V2500-A5/D5 SERIES PROPULSION SYSTEMS SERVICE BULLETIN

This document transmits the Initial Issue of Service Bulletin EV2500-72-0410

ENGINE – HP COMPRESSOR VARIABLE VANE INNER SHROUDS – INTRODUCTION OF REVISED ONE
PIECE BUSHES

Detail at AA
Fig.1

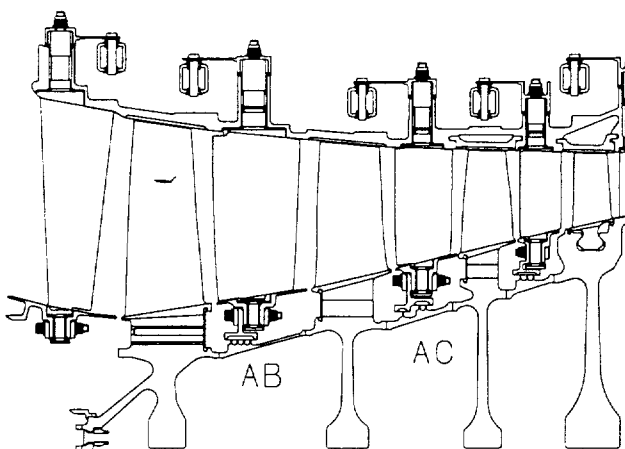
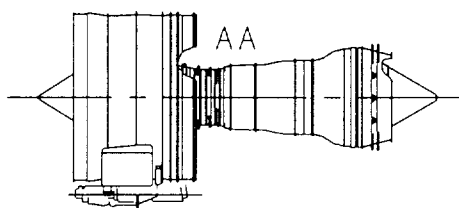
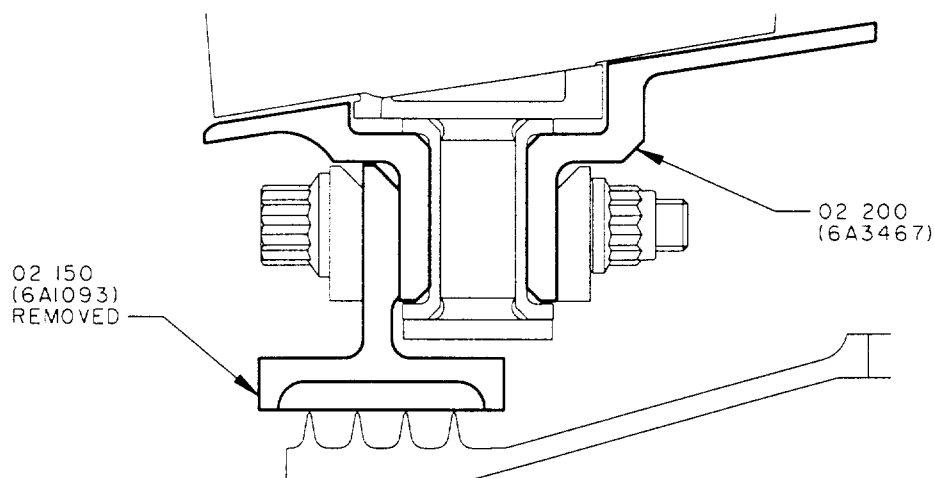
- (a) A revised one piece HP Compressor VSV inner spindle bush replaces the existing two piece bush across VIGV, stage 3, stage 4 and stage 5, similar to the existing item except for the following:
- (i) The graphite/polymide material is changed from Vespel SP211 to Vespel ST2030.
 - (ii) The inner and outer diameters have been changed to suit the thermal properties of the revised material.

- (b) Revised HP Compressor VIGV, stage 3, stage 4 and stage 5 vanes, similar to the existing items except for the following:
 - (i) The penny at the base of the vane spindle is deleted to suit the one piece bush.

- (ii) A manufacture option to machine a fillet radius as an alternative to the undercut.
- (c) A revised HP Compressor VIGV shroud assembly, similar to the existing item except for the following:

- (i) A lip is introduced to the inner spindle hole as a retention feature for the bush.
 - (ii) The inner spindle hole diameter is increased to suit the revised one piece bush.

Detail at AB before and after alteration
Fig.2

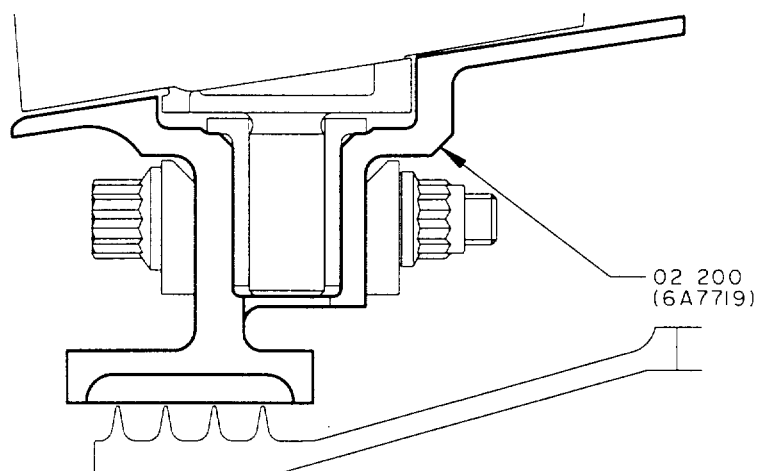
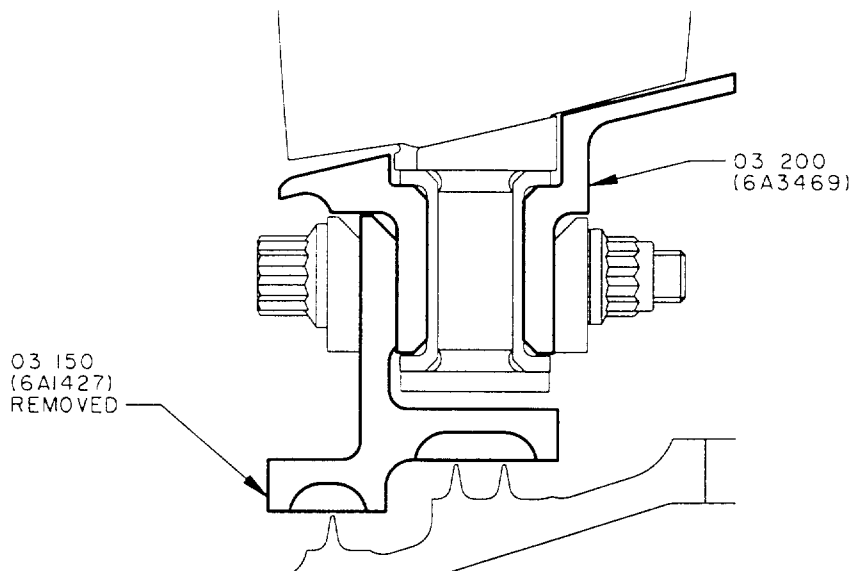
- (d) A revised HP Compressor stage 3 shroud half assembly, similar to the existing item except for the following:
 - (i) A lip is introduced to the inner spindle hole as a retention feature for the bush.

- (ii) The inner spindle hole diameter is increased to suit the revised one piece bush.
 - (iii) Revised location pins and retaining rings.
 - (iv) The stage 3 inner static seal is now an integral part of the shroud half assembly.

- (e) As described above, the stage 3 inner static seal is deleted as a separate item, the features are now incorporated within the stage 3 shroud half assembly.

- (f) Revised stage 3 inner shroud attaching bolts similar to the existing item except for a reduction in length.
- (g) A revised HP Compressor stage 4 shroud half assembly, similar to the existing item except for the following:

Detail at AC after modification
Fi. 3

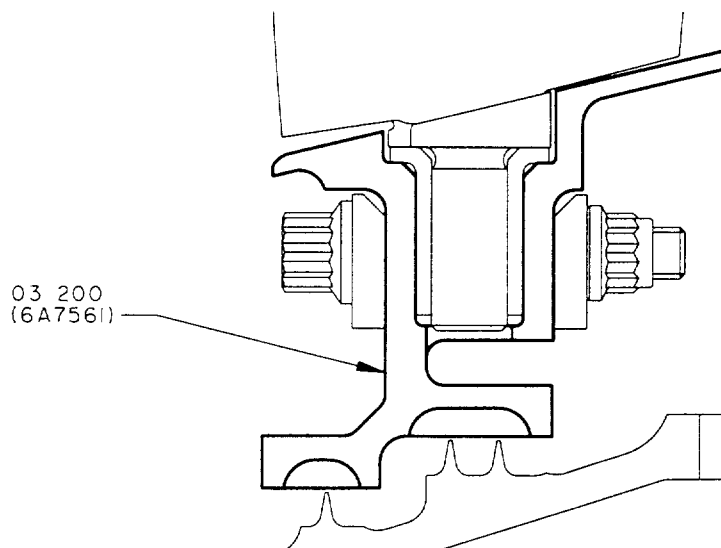
- (i) A lip is introduced to the inner spindle hole as a retention feature for the bush.
 - (ii) The inner spindle hole diameter is increased to suit the revised one piece bush.

- (iii) Revised location pins are introduced.

- (iv) The stage 4 inner static seal is now an integral part of the shroud half assembly.
- (h) As described above, the stage 4 inner static seal is deleted as a separate item, the features are now incorporated within the stage 4 shroud half assembly.

- (i) Revised stage 4 inner shroud attaching bolts, similar to the existing item except for a reduction in length.
- (j) A revised HP Compressor stage 5 shroud half assembly, similar to the existing item except for the following:

View showing vane rework typical all stages
Fig.4

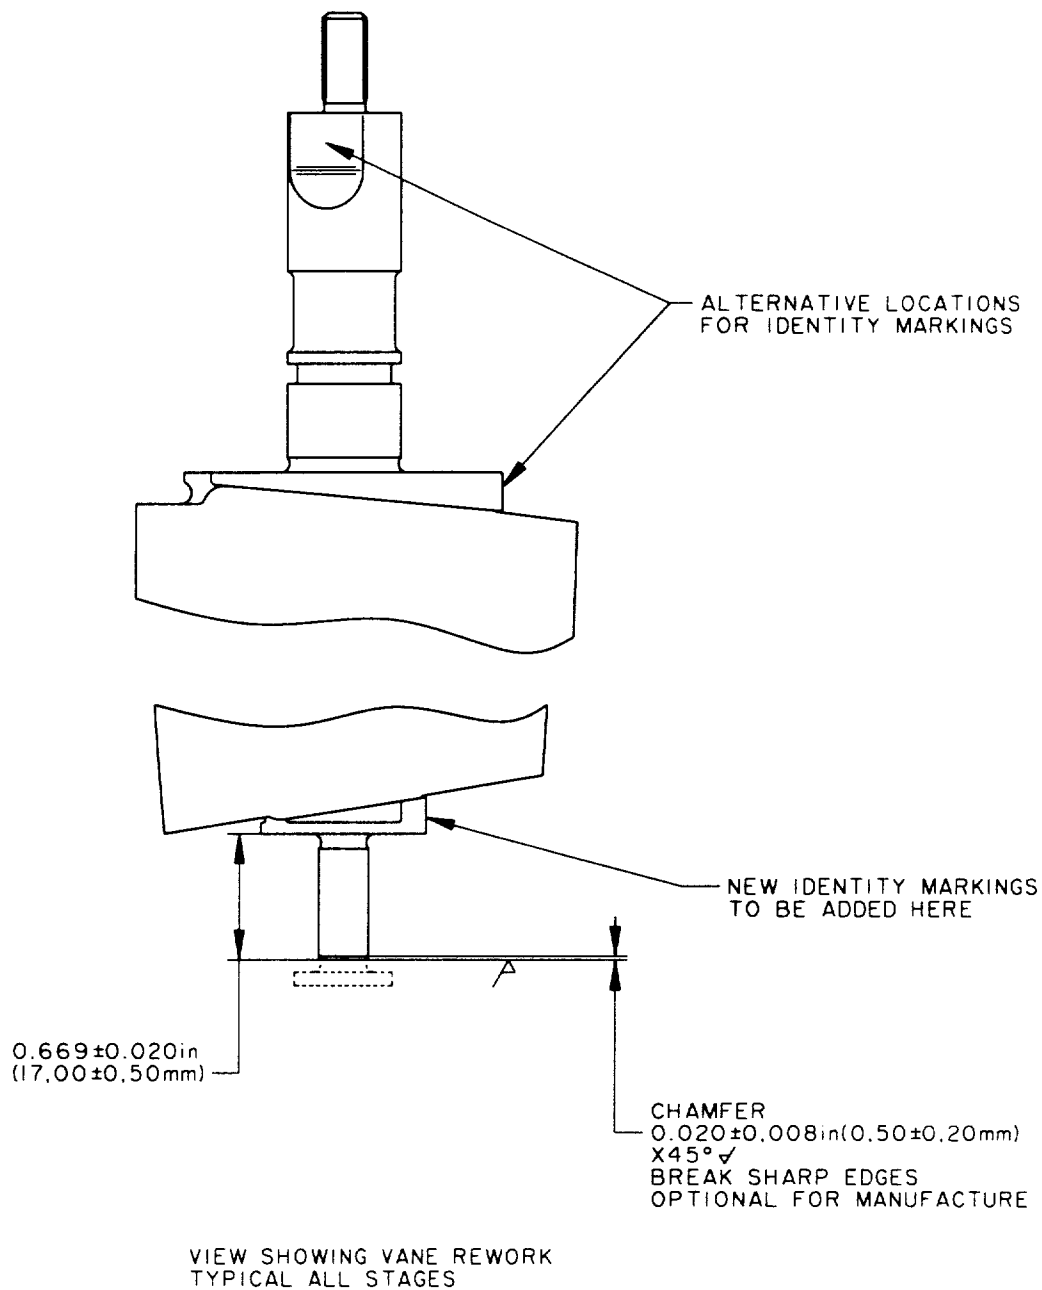
- (2) Existing HP Compressor Vanes may be reworked, refer to Fig 4.
- (3) This Service Bulletin is in five parts as follows:
 - Part 1 – Covers full embodiment of HP Compressor VIGV, stage 3, stage 4 and stage 5.

| (b) Machine the VIGV to length | Refer to Fig 4. Use standard workshop equipment |
| (c) Machine the chamfer on the VIGV | Refer to Fig 4. Use standard workshop equipment |

(b) Machine the vanes to length

(c) Machine the chamfer on the vanes

MACHINE WHERE MARKED ✓
SURFACE FINISH TO BE 125 MICROINCHES (3.2 MICROMETRES)
